**NEW YORK STATE THRUWAY AUTHORITY  
DEPARTMENT OF ENGINEERING**

**AMENDMENT NO. 1  
TO**

**CONTRACT TAS 26-10A  
D215078  
PORT BYRON SERVICE AREA  
WATERMAIN REPLACEMENT  
AT I-90, MILEPOST 310.20  
IN THE SYRACUSE DIVISION  
OF THE NEW YORK STATE THRUWAY  
IN CAYUGA COUNTY**

**IN THE LETTING OF  
JANUARY 7, 2026**

## OVERALL PLAN

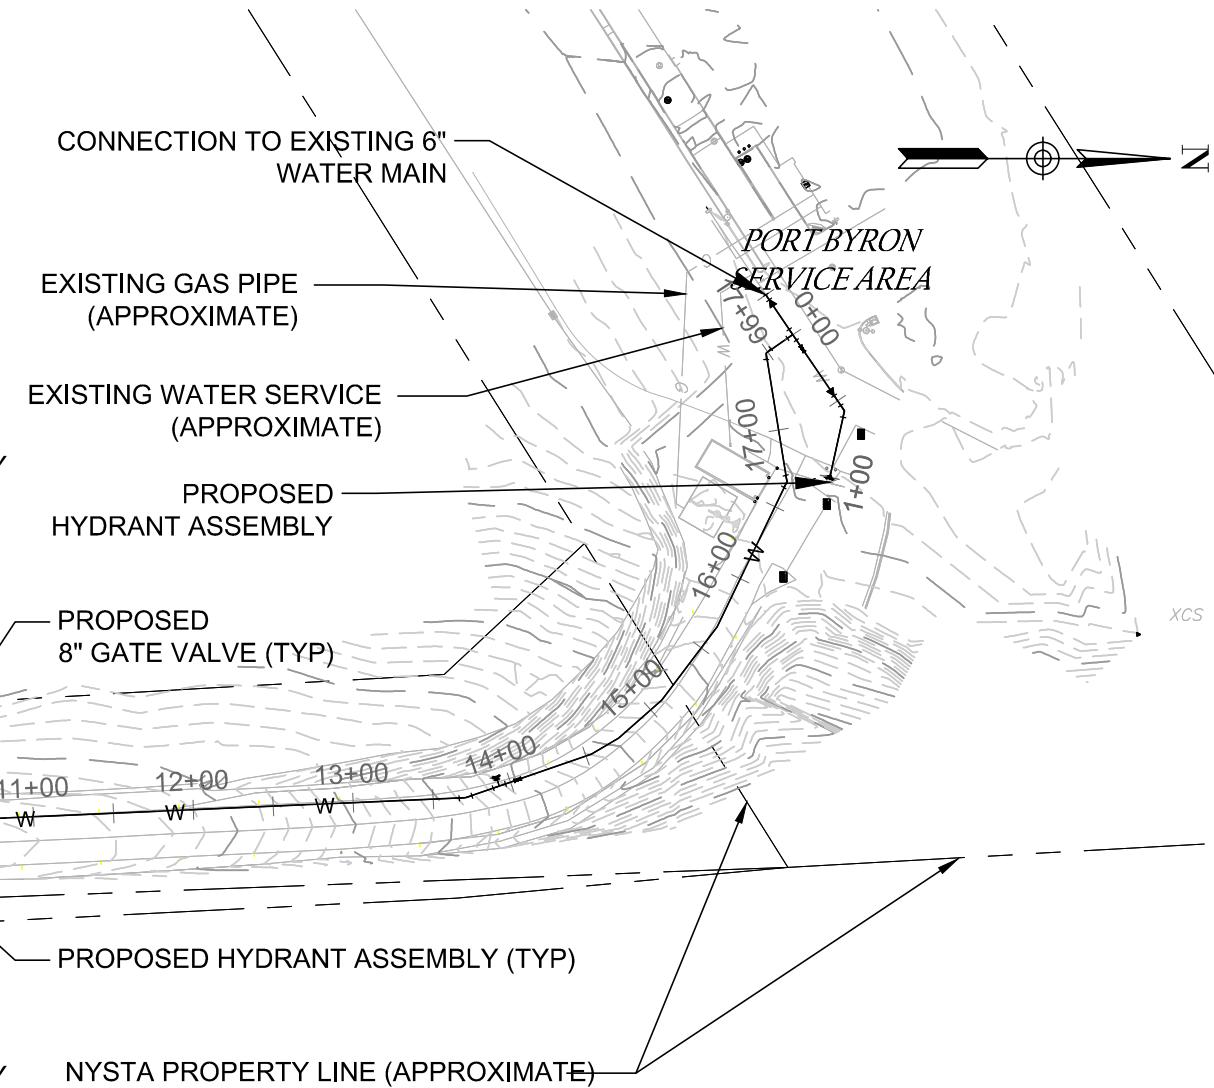
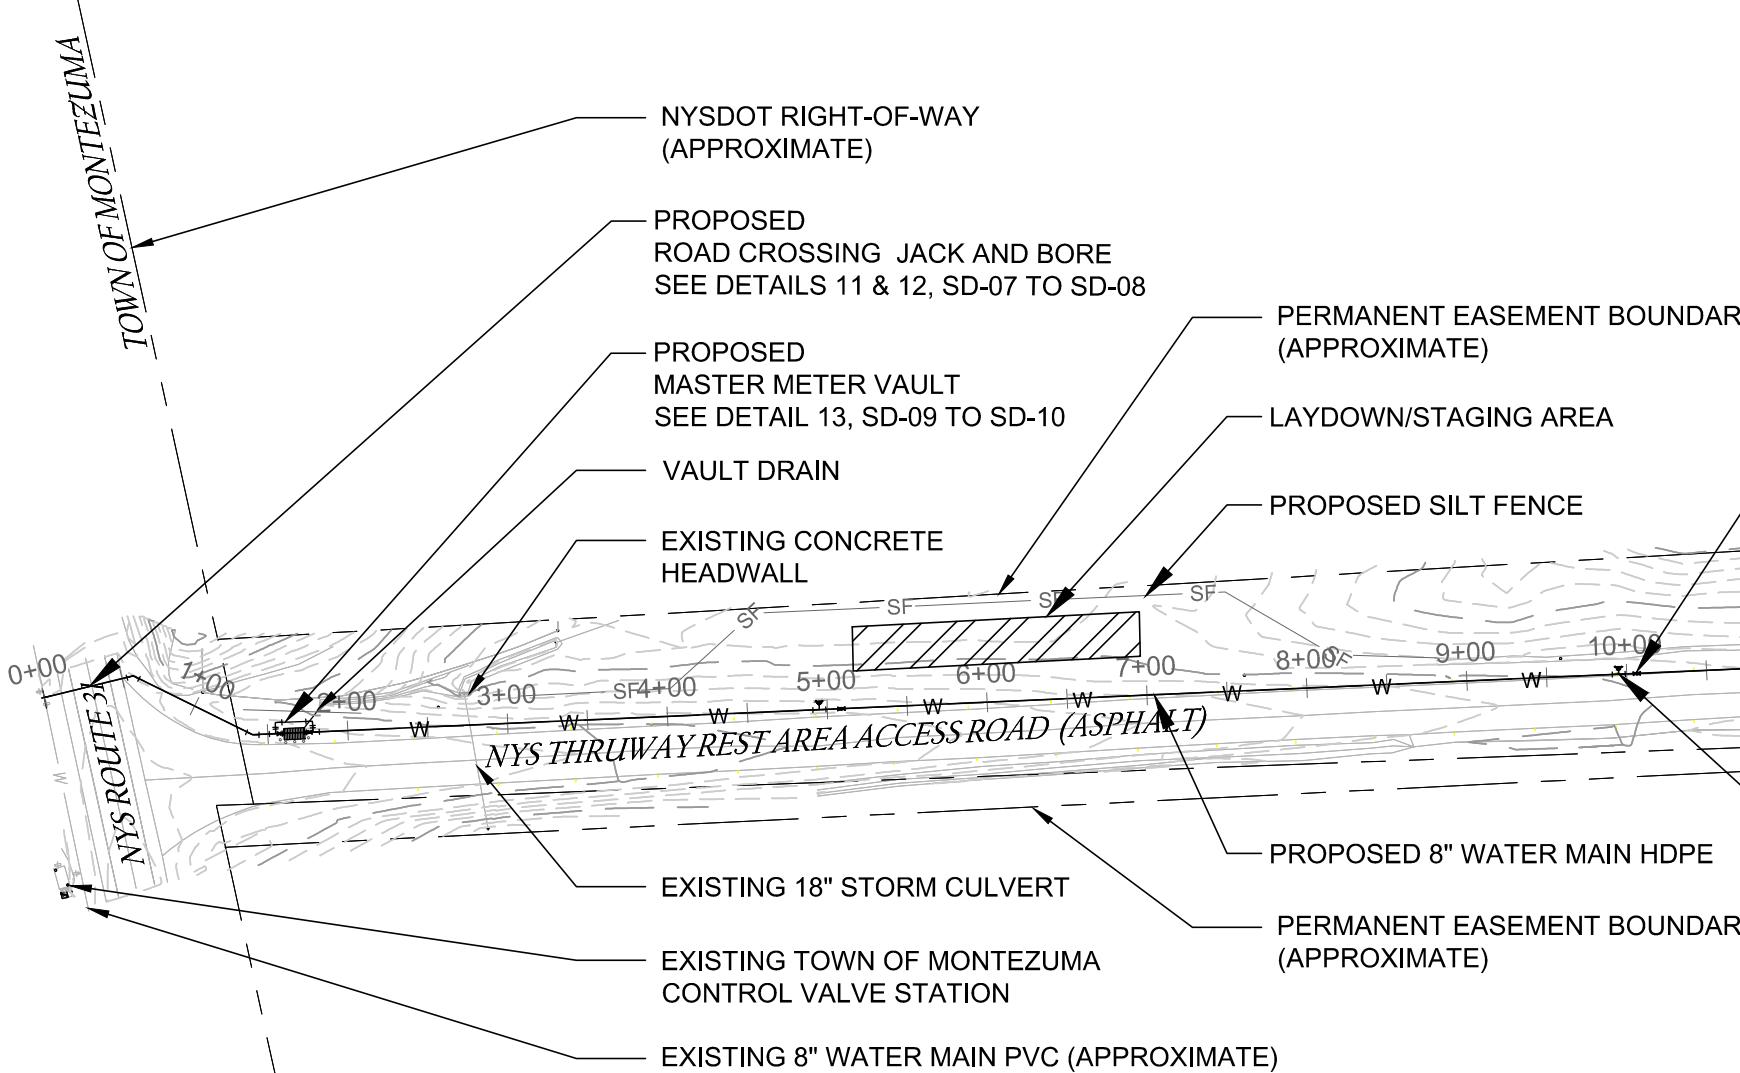
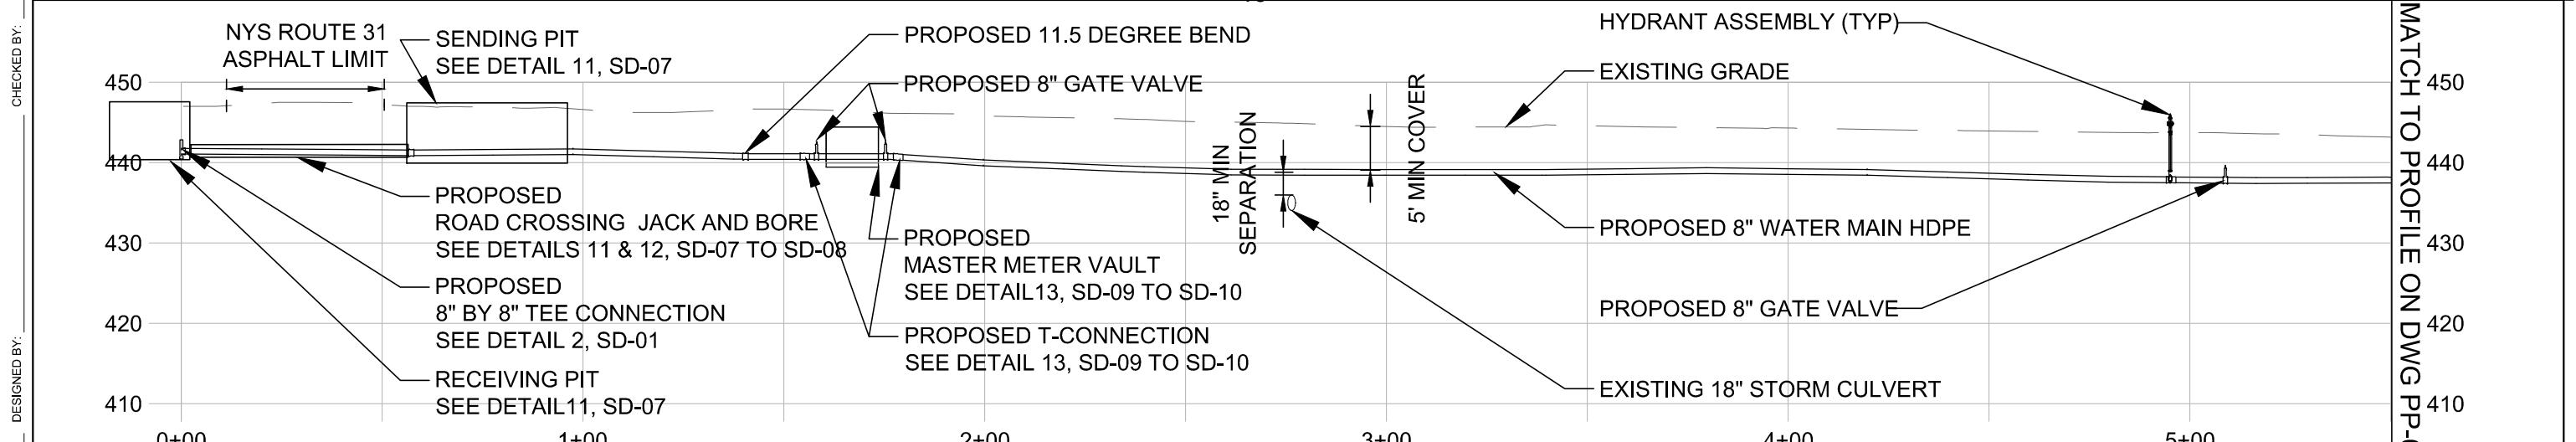
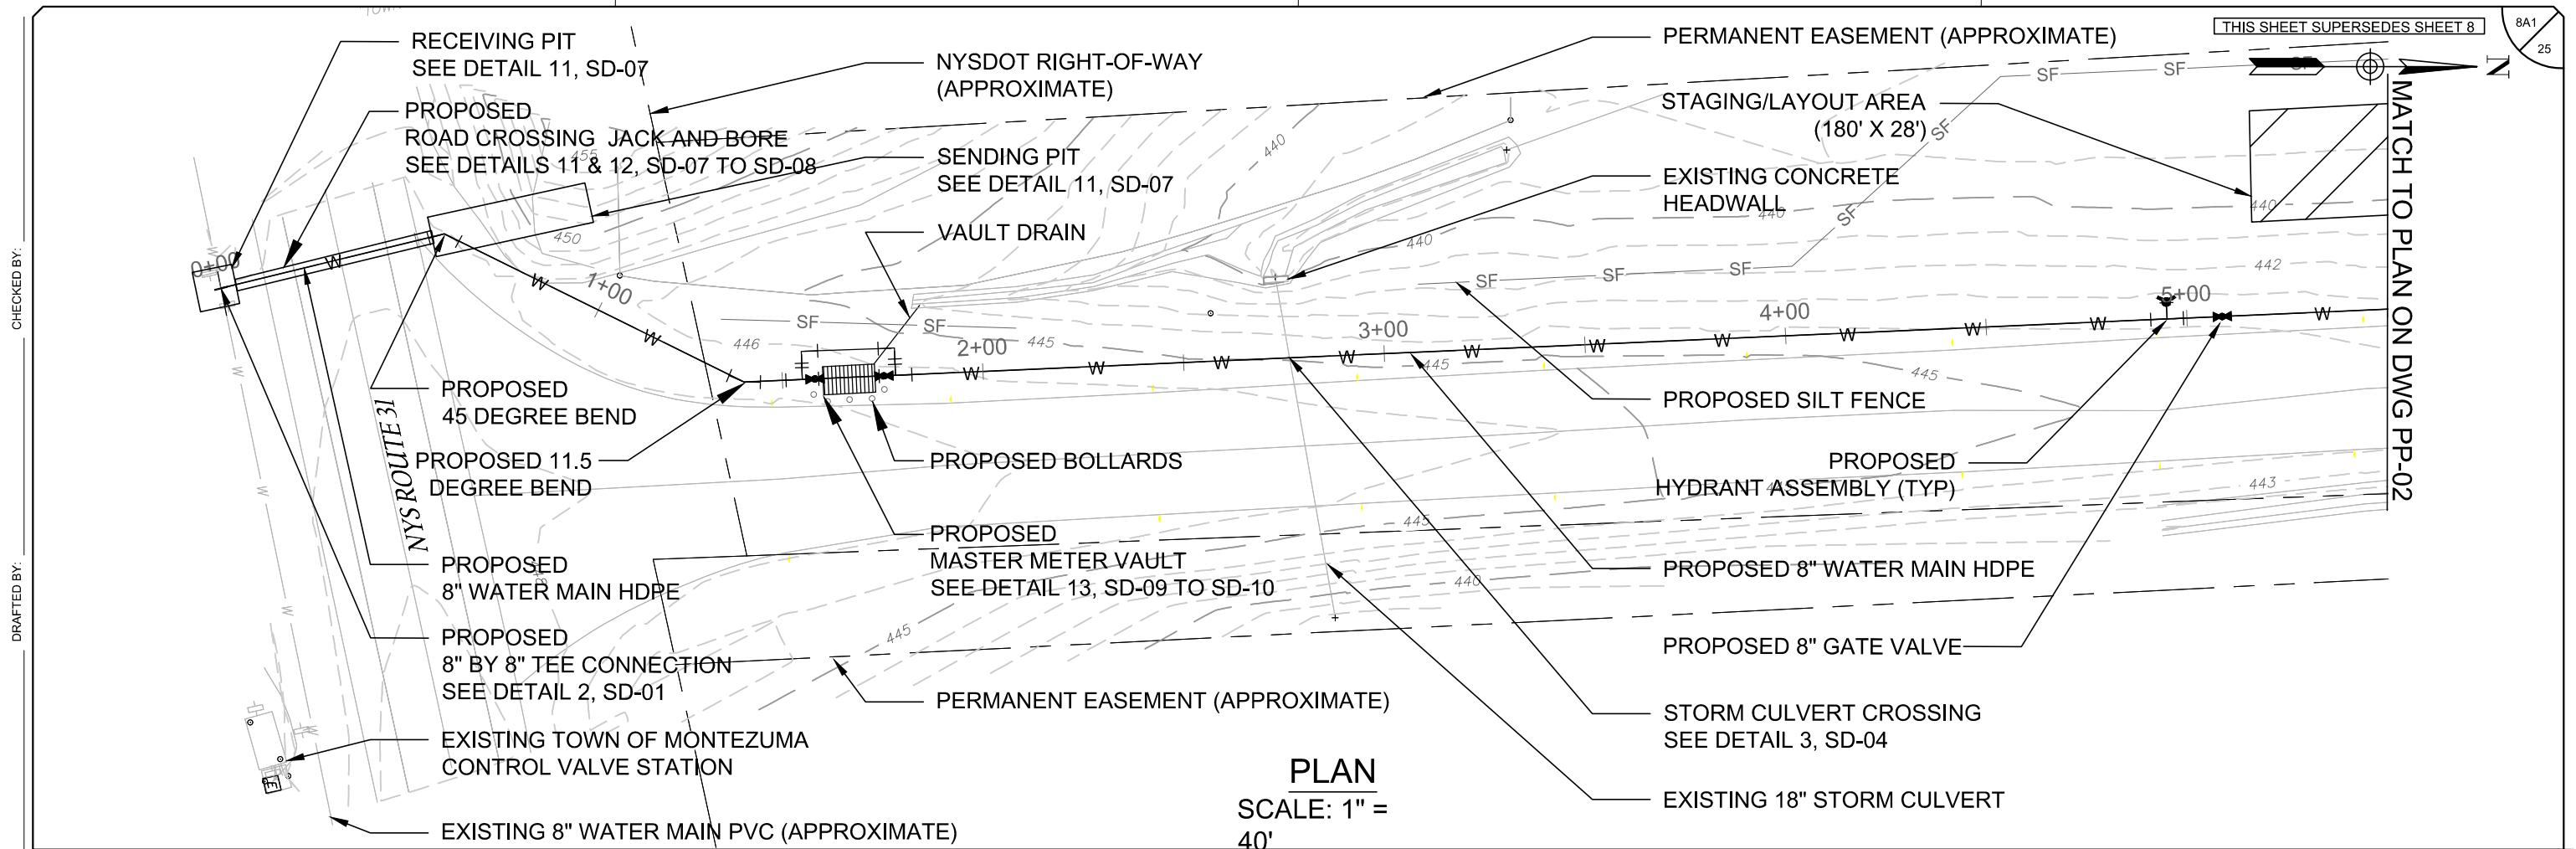
2. **DELETE** Drawing Number SP-02, Sheet 7 of 25 and **SUBSTITUTE** with the attached Drawing Number SP-02, Sheet 7-A1 of 25. Previous references to the proposed Ductile Iron Pipe (DIP) have been updated with HDPE (High Density Polyethylene), instead.

TITLE OF PROJECT  WATER MAIN REPLACEMENT		CONTRACT NUMBER:  TAS: 26-10A
LOCATION OF PROJECT  PORT BYRON SERVICE AREA (MP 310.2)		DATE:  12/19/2025
TITLE OF DRAWING  PLAN & PROFILE  STA: 0+00 TO 5+50		DRAWING NUMBER:  PP-01

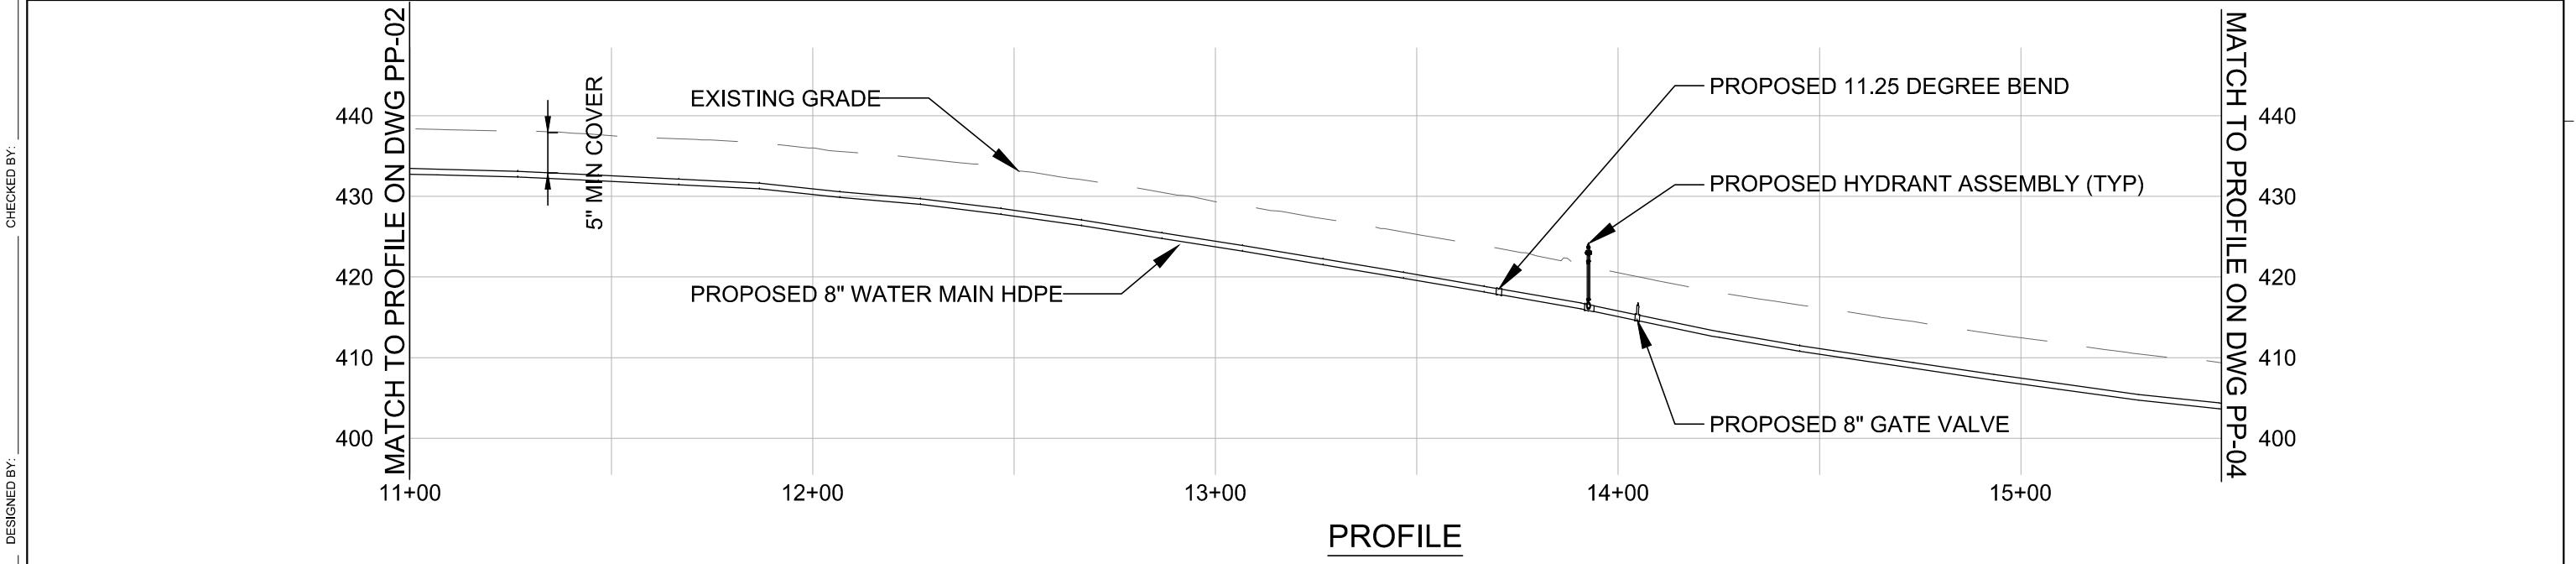
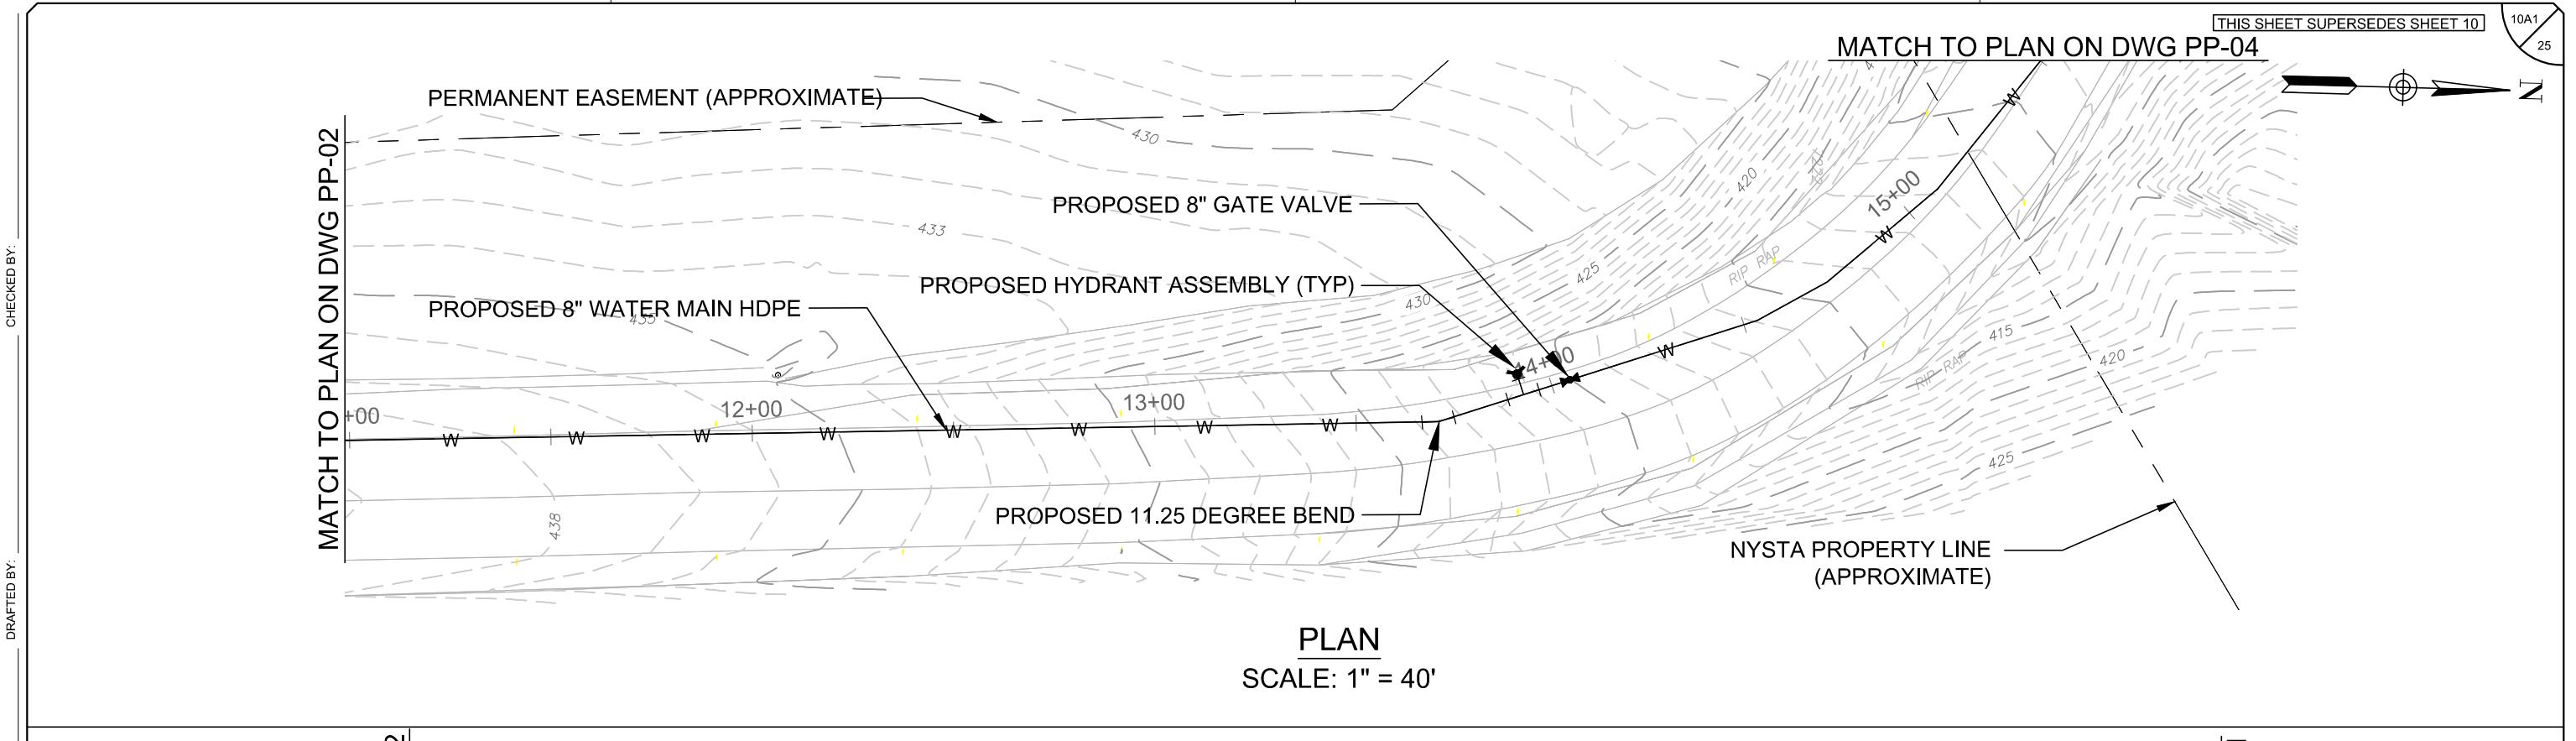
3. **DELETE** Drawing Number PP-01, Sheet 8 of 25 and **SUBSTITUTE** with the attached Drawing Number PP-01, Sheet 8-A1 of 25. Previous references to the proposed Ductile Iron Pipe (DIP) have been updated with HDPE (High Density Polyethylene), instead.
